**UNITED STATES OF AMERICA
BEFORE THE NUCLEAR REGULATORY COMMISSION**

_____)	
In the Matter of)	
)	
Proposed Rule: Waste Confidence –)	
Continued Storage of Spent Nuclear Fuel)	Docket No. 2012-0246
10 C.F.R. Part 51)	
)	
Draft Waste Confidence Generic)	
Environmental Impact Statement)	
_____)

**Comments by Environmental Organizations
on Draft Waste Confidence Generic Environmental
Impact Statement and Proposed Waste Confidence Rule****And****Petition to Revise and Integrate All Safety and Environmental Regulations
Related to Spent Fuel Storage and Disposal****I. INTRODUCTION**

Figure 1. Burnup trends for PWR and BWR reactors in the United States (Reproduced from IAEA 2011, Fig. 6 (p. 9), with note: Courtesy of Energy Resources International)

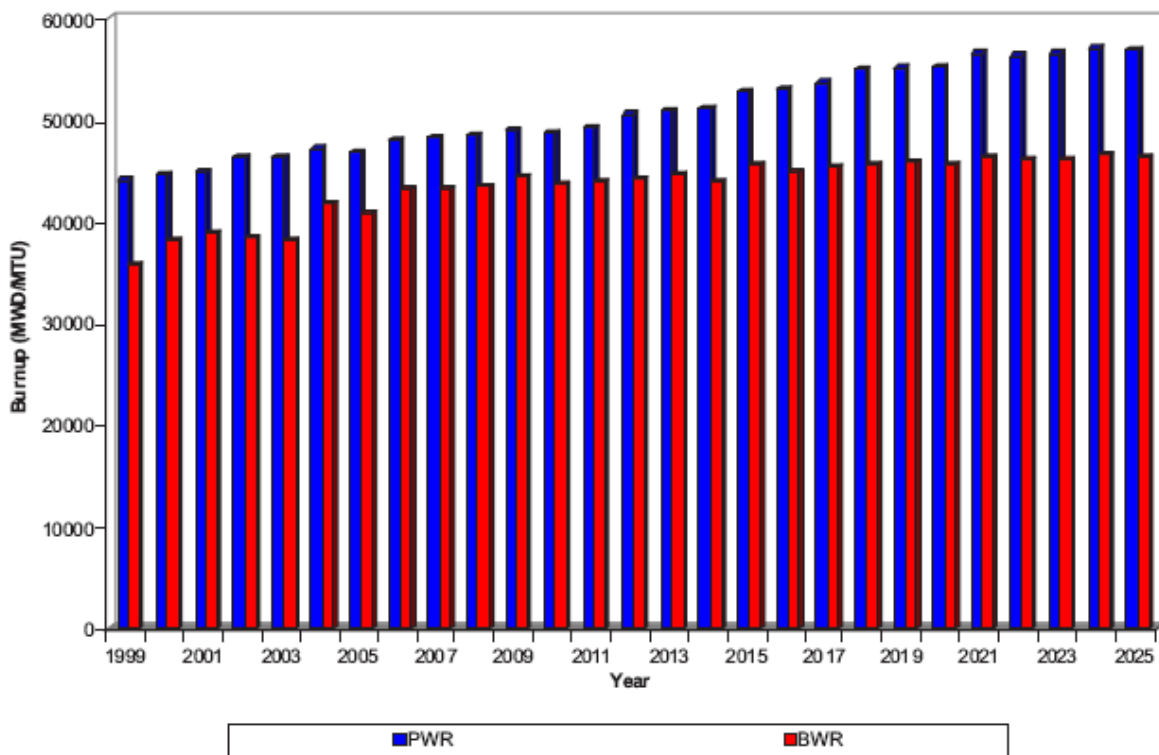
Figure 1 shows the trends in burnup for PWRs and BWRs. It shows that high burnup fuel (more than 45 GWd per metric ton) started being discharged from reactors only around the turn of the century. Most of this is still in spent fuel pools. Examination of high burnup spent fuel after dry storage of 15 years, as was done for low burnup Surry fuel,⁵³ is not yet possible, though some experimental work with high burnup fuel cladding has been done.⁵⁴

Figure 2. Cladding outer surface oxide thickness layer versus rod average burnup (Reproduced from NWTRB 2010, Figure 20 (p.56))

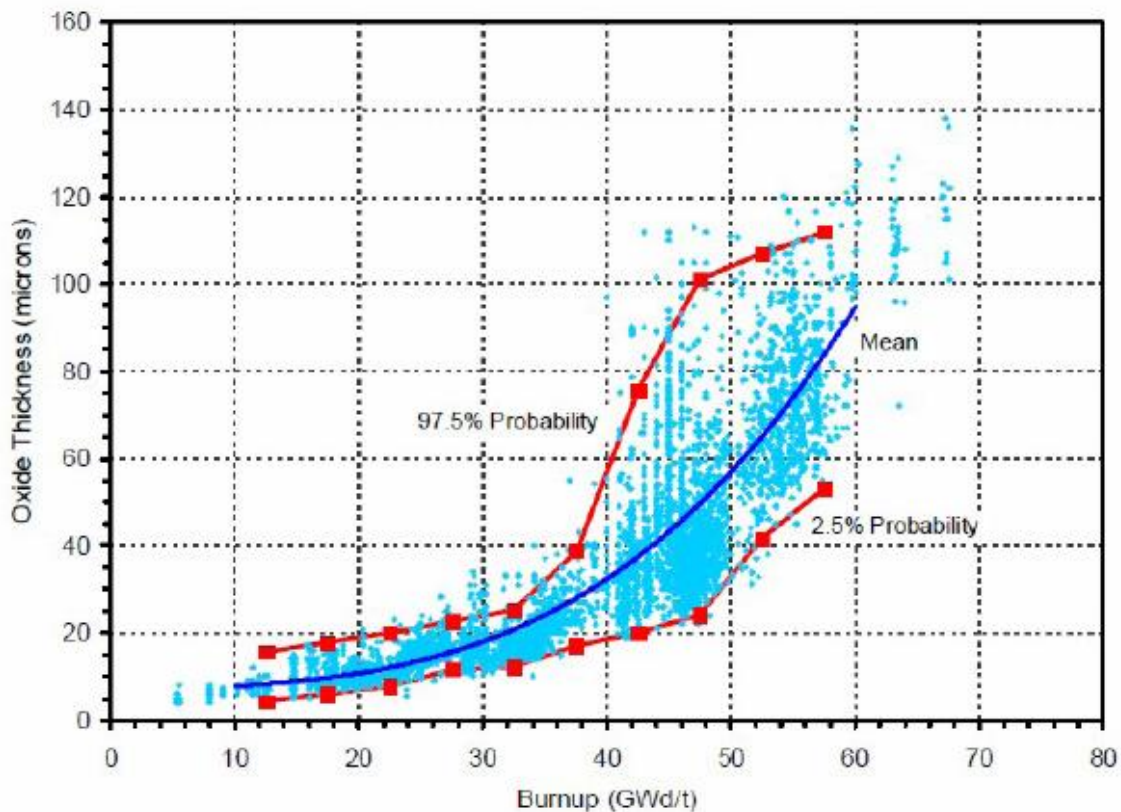
4.21. High burnup fuels also tend to build up much thicker levels of oxide during the in-reactor period as well as much higher levels of hydrogen in the cladding. Figure 2 below shows that the typical increase in outer oxide layer thickness increases from about 20 microns at 30 GWd/MTU to about 100 microns at about 62 or 63 GWd/MTU at discharge from the reactor.⁷² Moreover, the spread in the oxide layer thickness increases with burnup, indicating that some fraction of fuel rods may be at a much greater risk of failure.

4.22. Figure 3 shows that the maximum wall thickness hydrogen content increases from 200 ppm to 800 ppm at discharge over approximately the same burnup range as in Figure 2. In both cases the variability is also much greater at the higher burnup. For instance, Figure 3 shows oxide layer thicknesses for a burnup of 30 GWd/metric ton ranging from roughly 12 microns to (at most) 35 microns – a spread of 23 microns. At 63 GWd per metric ton the thickness range from

about 70 microns to 130 microns, a spread of 60 microns. In fact these data show that the *variability* in oxide layer thickness at 63 GWd/MT burnup is almost *twice as large as the maximum* thickness at 30 GWd/MT. The oxidation and hydriding in-reactor data point to (i) a higher probability of failure and (ii) more severe failures in some fraction of the rods in cases when failures occur upon prolonged spent fuel pool and dry storage for high burnup spent fuel. High oxide and hydrogen levels in cladding create a host of vulnerabilities in spent fuel, including increased brittleness upon drying, high hoop stresses, and other phenomena that could cause fuel to fail – that is, to develop cracks and fissures that are significant enough to cause release of fission products. Reasonable confidence in the integrity of spent fuel after long periods of storage would not only require examination of typical high burnup fuel rods but also the ones at the higher levels of initial degradation that are clearly indicated by currently available information of in-reactor performance.

Figure 2-4. Continued Storage Timeline

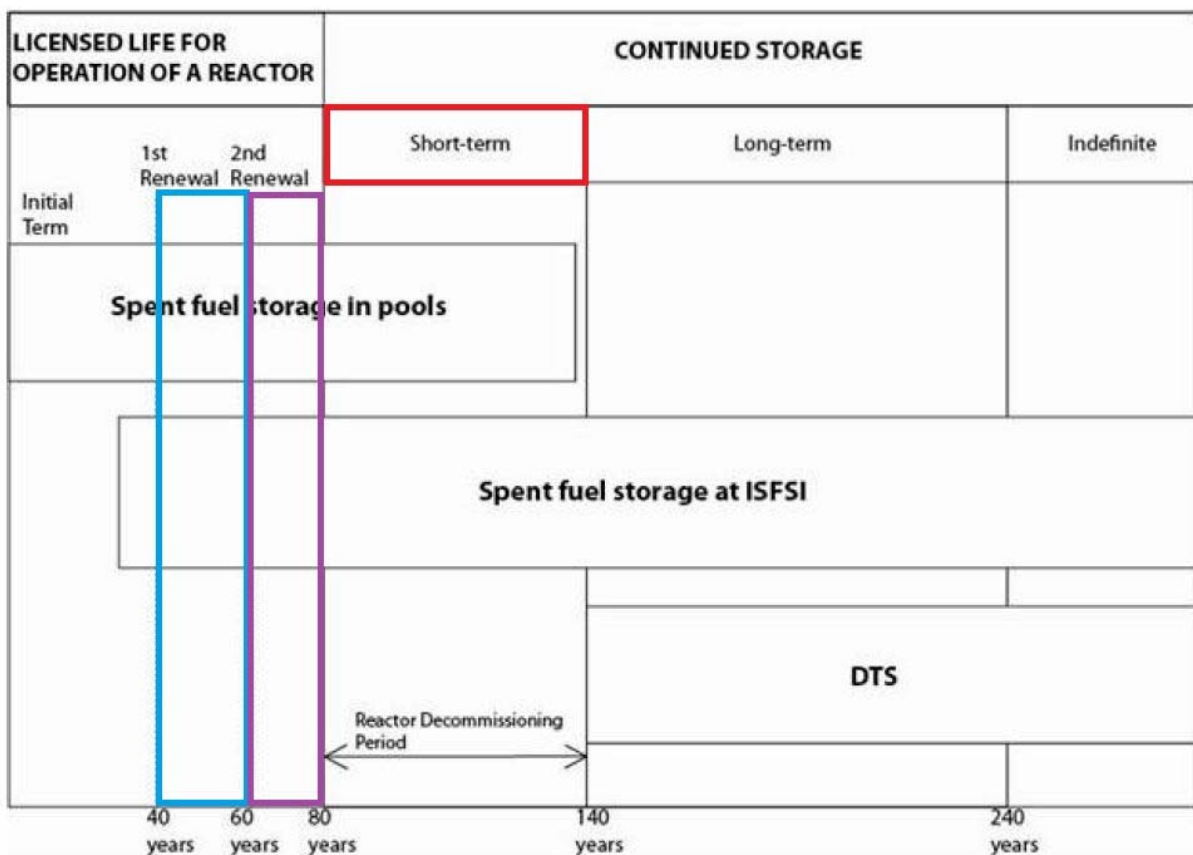
7.39 But the period of extended operation only covers the duration of reactor operation, not to the end of the 60-year short-term storage period as clearly illustrated in Figure 2.4 of the WC DGEIS:
